City of Richmond
Urban Development Division

Report to Committee

Re: **Application by Jacken Investments Inc. for Rezoning at 11351, 11391, 11411, 11431, 11471 and 11491 Steveston Hwy. from Single-Family Housing District, Subdivision Area E (R1/E) to Townhouse District (R2-0.6)**

RZ 04-276170

FIRE FIGHTING PLAN
 SCALE: 1" = 100'-0"

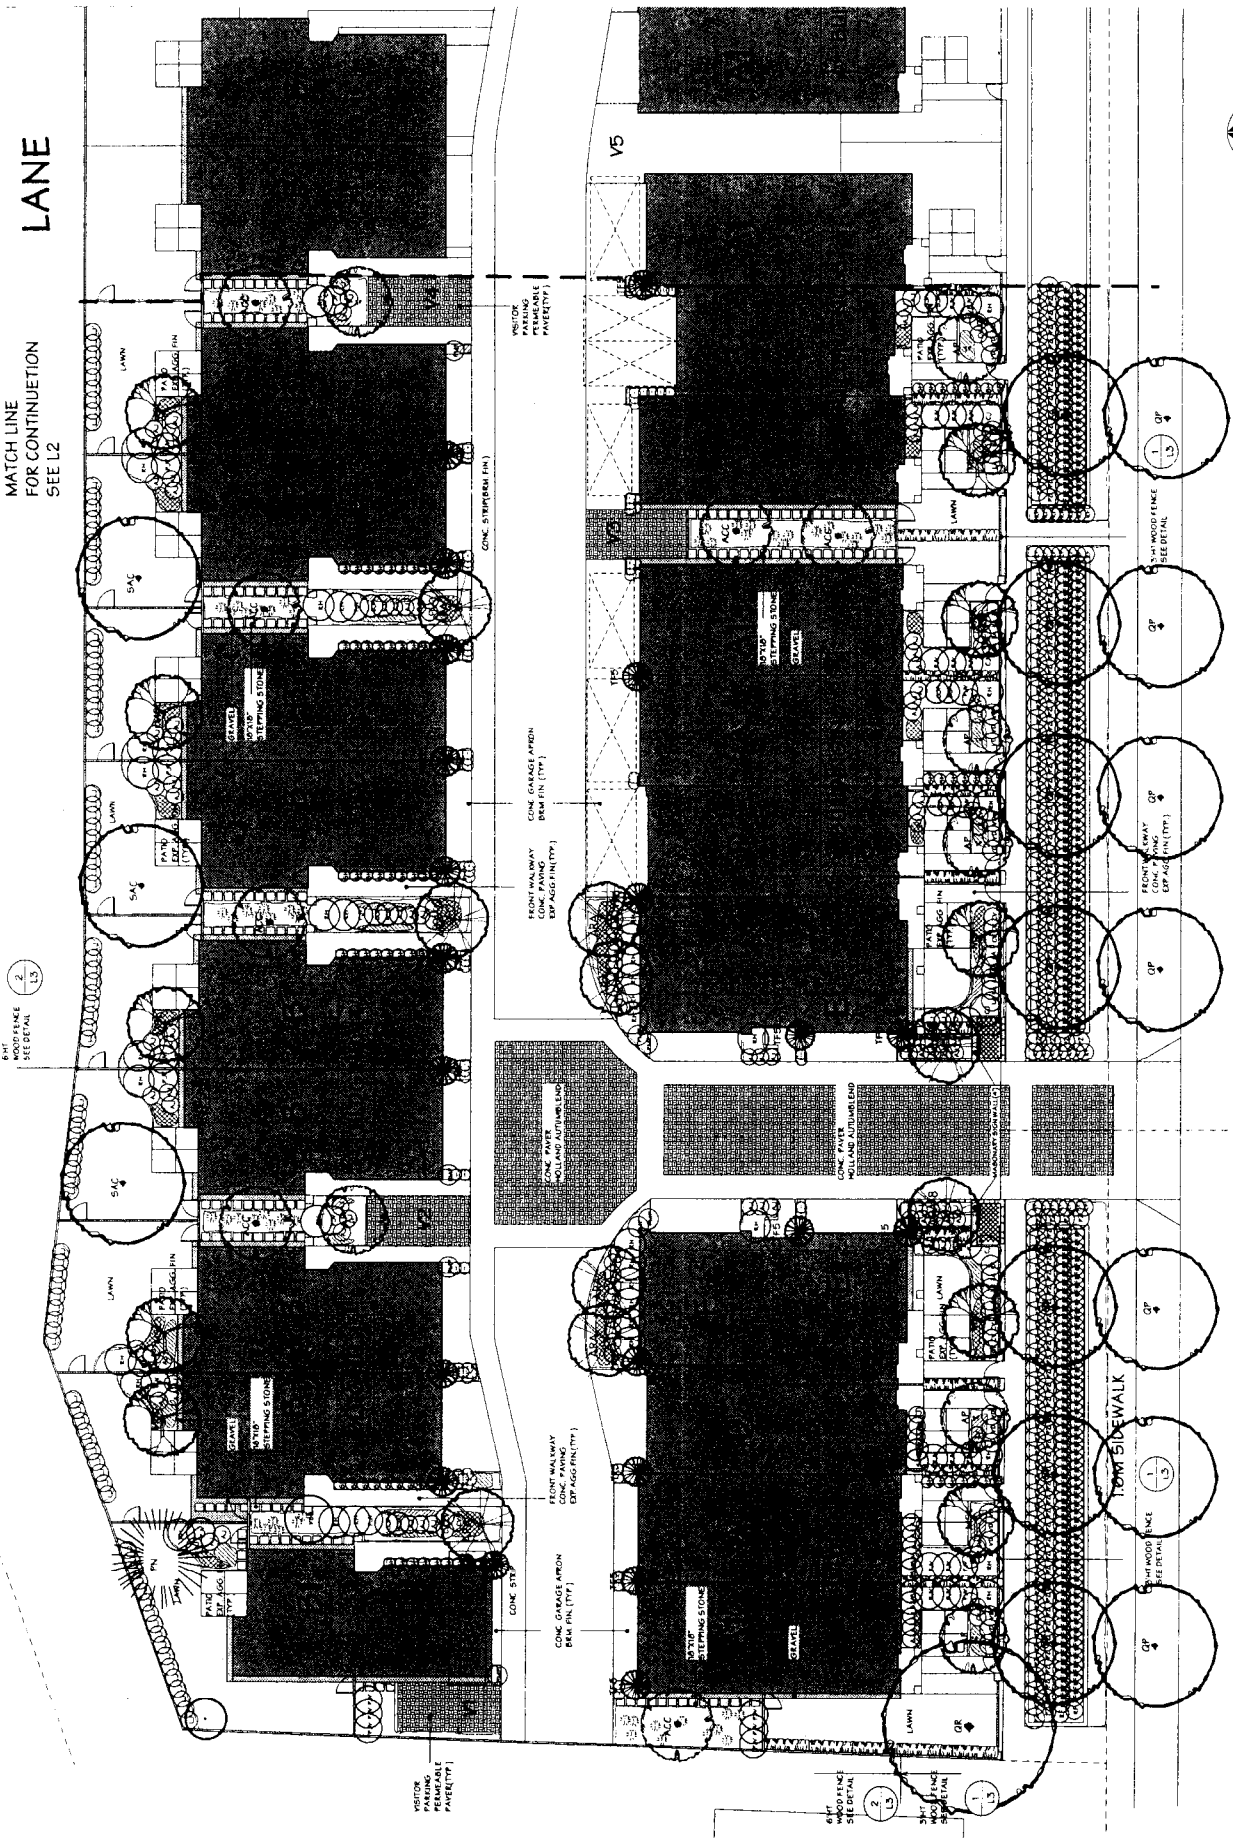
The applicant has worked with Staff to adjust the plans and address issues raised during the technical review. Adjustments were made to the design, for example, to accommodate turning radii needed for Fire Department vehicles to access the site. The applicant has worked closely with Fire Department staff to design a workable fire fighting plan for the site.

TREE RETENTION PLAN

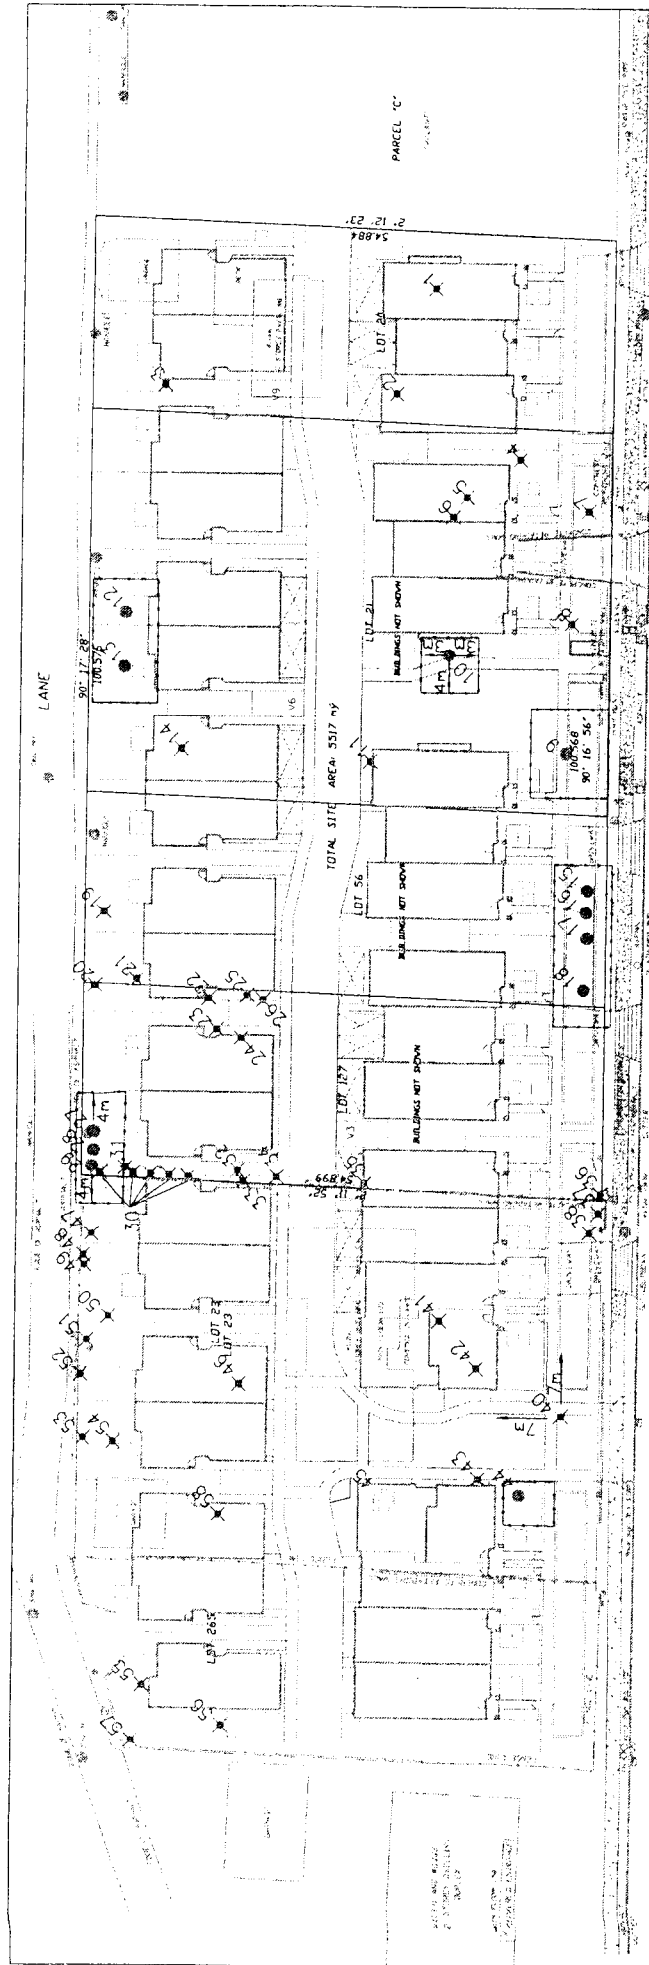
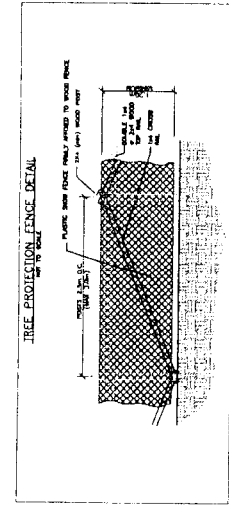
Where trees were found to be in poor condition or worse, the trees were specified for removal, unless their location and/or the defect allowed safe retention. Trees that were candidates for retention (all other trees) were reviewed for construction impacts. The designation for treatment and rationale for removal are provided in the tree list for reference. All trees proposed for retention are specified as such conditional to further reviews during the detailed design and construction phases of the project. A major conflict with many of the trees selected for retention is the need to pre-load the site in preparation for building the townhouses. This process is highly destructive to roots and soil hydrology. The developer has agreed to have his design consultants and geo-technical engineer look into pre-load slope retaining devices and interim drainage systems to reduce pre-load impacts in proximity to the retained trees.

10	70	Saucer magnolia	Fair	Decay in the leader union makes it a poor candidate for transplant, but it is viable for retention if the design can accommodate it.	RETAIN	Pre-load conflicts must be resolved, and pruning would be required if building footprint remains as presented currently.
11	30	Purple-leaved plum	Fair	Heavy sucker growth.	Remove	In building envelope
12	40	Cherry	Fair		RETAIN	Pre-load conflicts must be resolved, and pruning would be required if building footprint remains as presented currently.
13	35	Cherry	Fair		RETAIN	Pre-load conflicts must be resolved, and pruning would be required if building footprint remains as presented currently.
14	35	Cherry	Fair		Remove	In building envelope

Tree #	Dbh	Species	Condition	Comments:	Treatment	Rationale/Notes:
15	35	Purple-leaved plum	Poor	Some dieback noted, but valuable tree in frontage landscape.	RETAIN	Note the conflict with the proposed berm. Conditional to city approval, re-design is required to maintain existing grades.
16	21	Purple-leaved plum	Poor	Some dieback noted, but valuable tree in frontage landscape.	RETAIN	Note the conflict with the proposed berm. Conditional to city approval, re-design is required to maintain existing grades.
17	28	Purple-leaved plum	Poor	Some dieback noted, but valuable tree in frontage landscape.	RETAIN	Note the conflict with the proposed berm. Conditional to city approval, re-design is required to maintain existing grades.
18	40	Purple-leaved plum	Poor	Some dieback noted, but valuable tree in frontage landscape.	RETAIN	Note the conflict with the proposed berm. Conditional to city approval, re-design is required to maintain existing grades.
